Planning Panels Victoria

Sandown Racecourse Advisory Committee

Final Report

Advisory Committee Report pursuant to section 151 of the PE Act

Figure 4 Active open space illustration from Mr Murphy's evidence

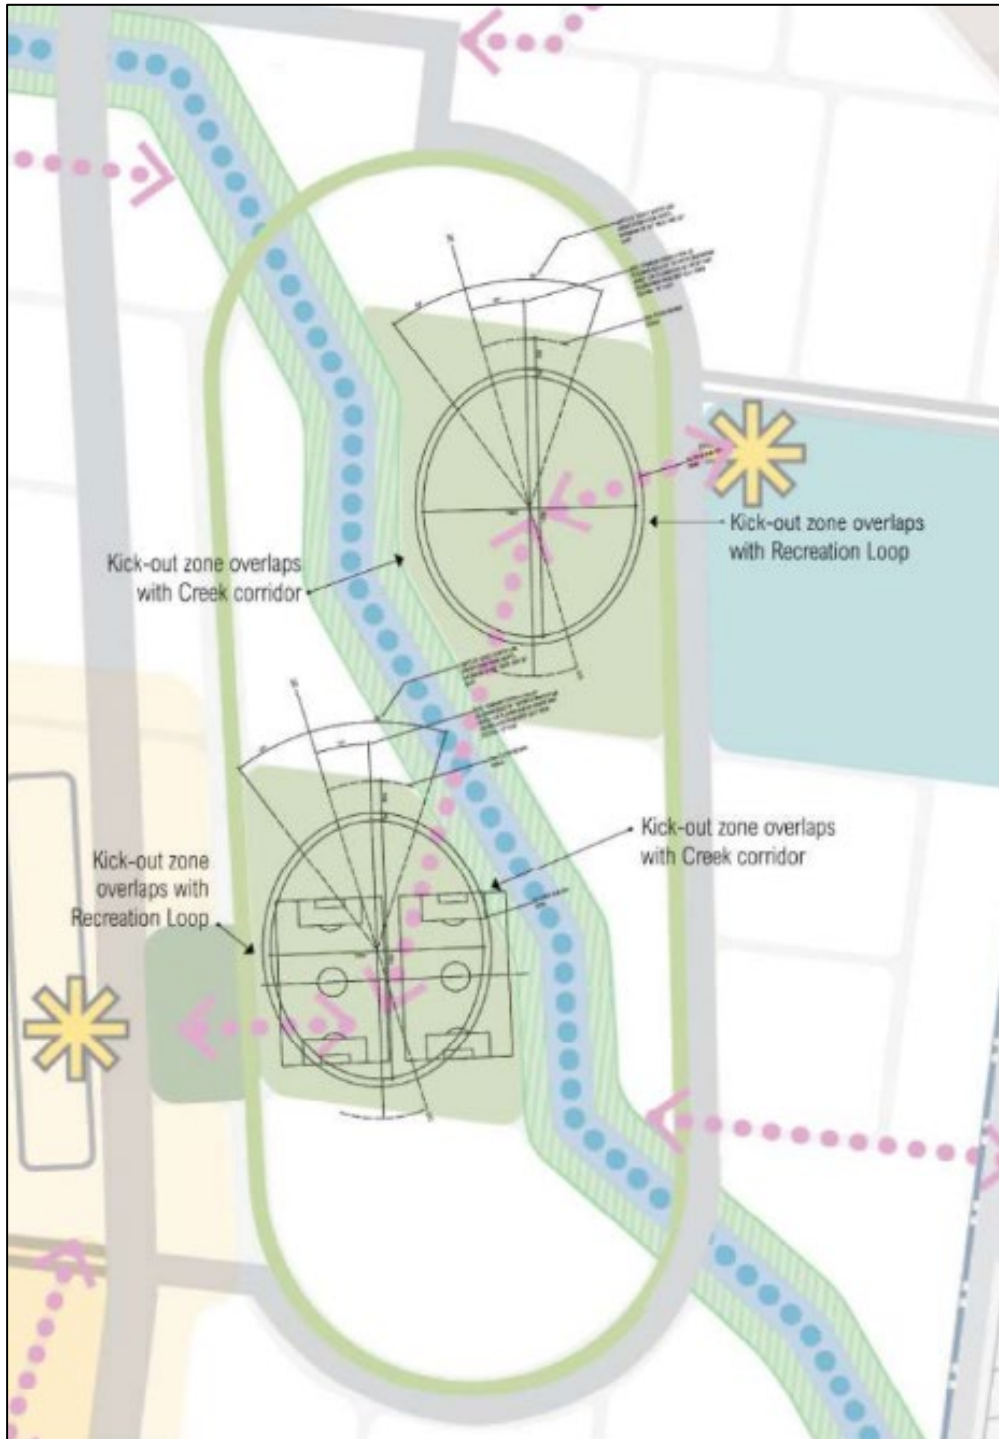
The Proponent relied on Mr Murphy's evidence that the CDP (Day 1) was a good outcome, except for the Active Open Spaces, which he believed were too tight for their designated activities as illustrated in Figure 4 ²⁶.

Figure 5 Adjusted Active Open Space

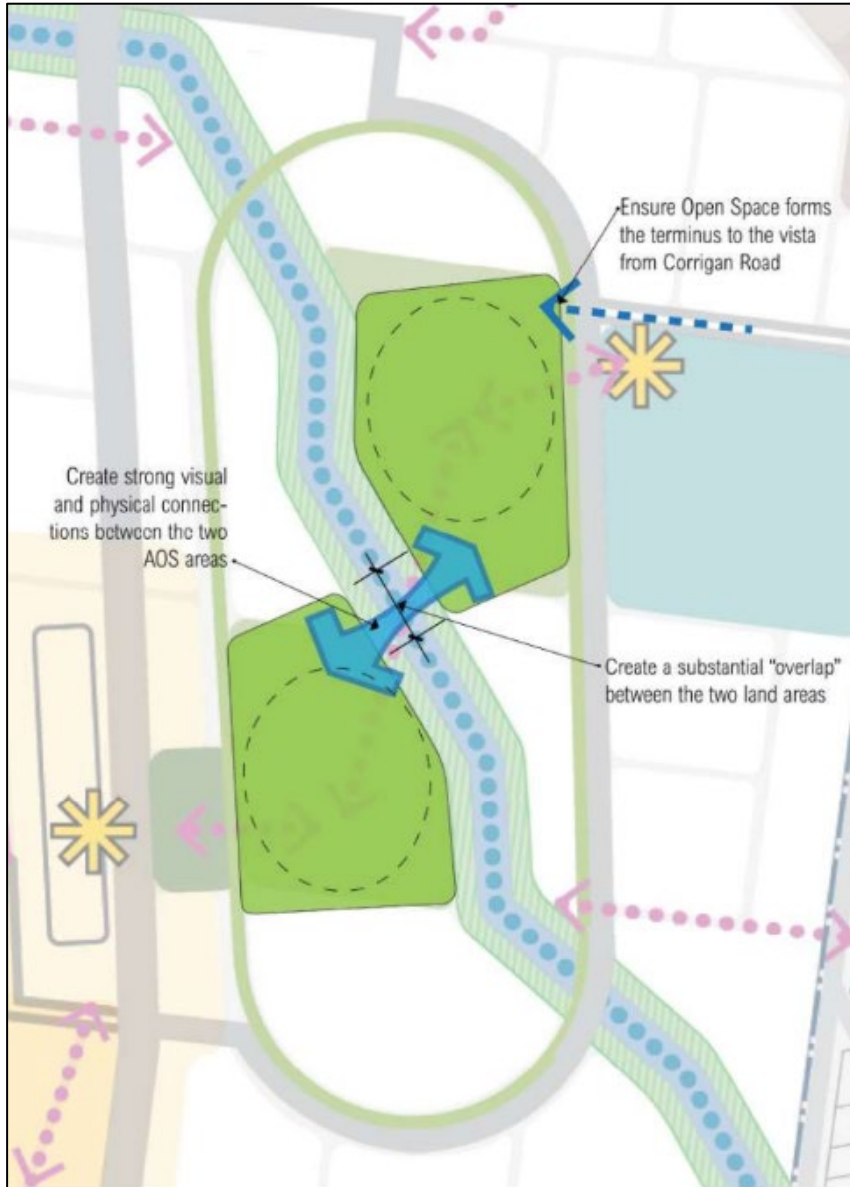
He proposed this could be overcome by a slight adjustment to the shapes of the two Active Open Spaces and the creation of a strong visual and physical connection between them as illustrated in Figure 5²⁷.

Figure 7 Alternative staging scenario

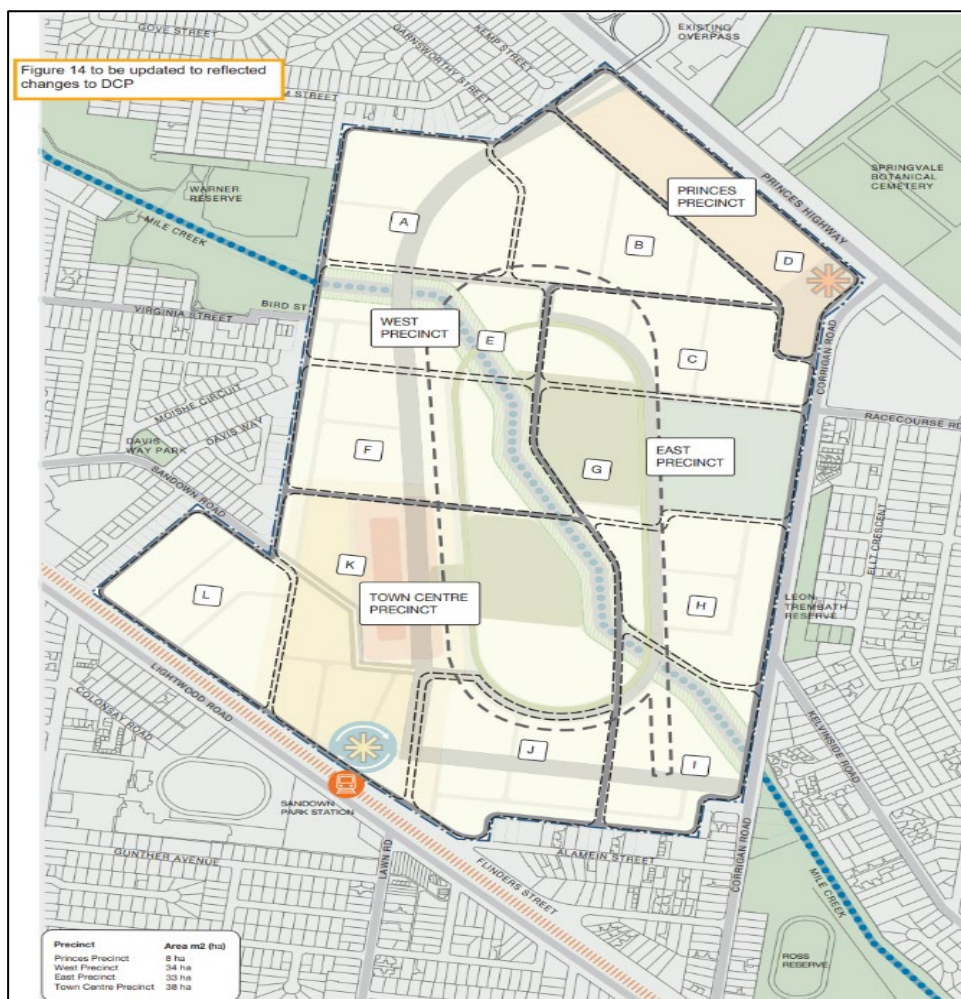
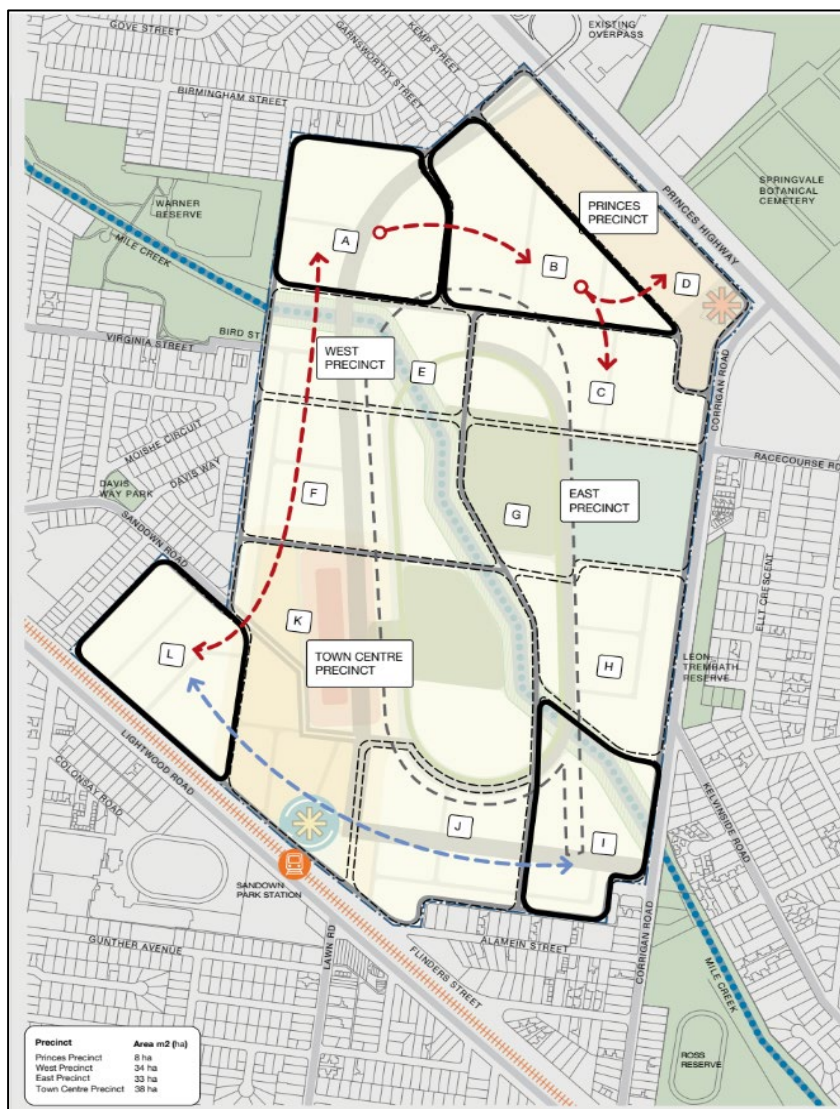
In response, the Proponent produced an alternative staging scenario where development initially commenced in the south west corner (Stage L) migrating across the southern end of the site (Stages J and L) then progressing north (Stages H and G) along Corrigan Road (essentially wrapping around the southern and eastern side of the race track) ⁴⁰. Concurrently, development along the west side of the track and progressing north could also occur (Stages K, F and E), with Stages A and B to be the last to be developed as shown in Figure 7 ⁴¹.

With regard to Figure 7, the Proponent noted if development commenced in Stage L, it:

- The Project does not give due regard to the Sandown Park Railway Station as a key locational advantage.
- The staging of the site should be amended to provide for development in the north and south concurrently, generally in accordance with the revised Staging Plan as shown at Figure 7.

- a) **In Chapter 4.10, replace the Staging Plan at Figure 13 with Scenario 2: Alternative Indicative Staging Plan in Document 208 (shown as Figure 7 in this Report).**

Figure 9 Virginia Street / Bird Street proposed ‘dog leg’ realignment

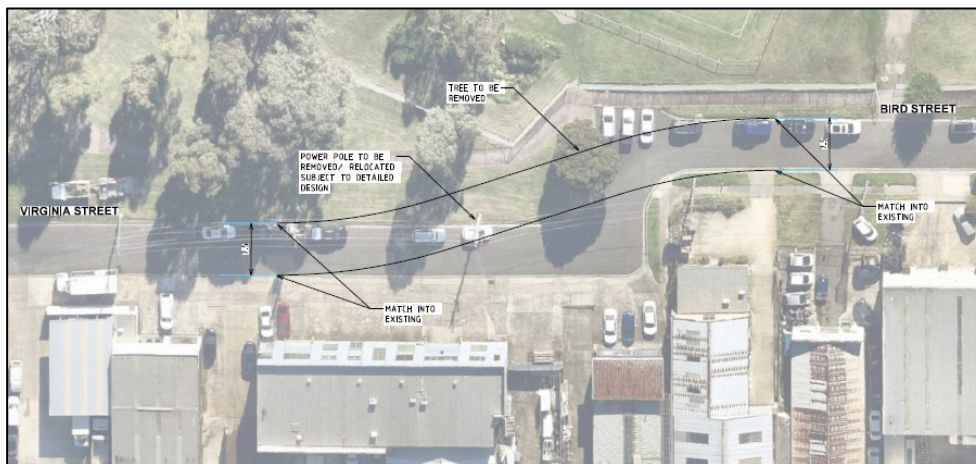
Mr Walsh’s evidence was:

- not an essential treatment but considering the additional traffic this section of road would carry, it would be desirable to flatten the bend to provide more convenient two-way traffic flow (refer to Figure 9)⁵¹
- this treatment would be subject to Council approval.

- c) In Chapter 4.10 Infrastructure and Staging edit Figure 14 – Location of Infrastructure items (Page 43) to:
 - Include Project RD-07 at the Virginia Street/Bird Street Intersection
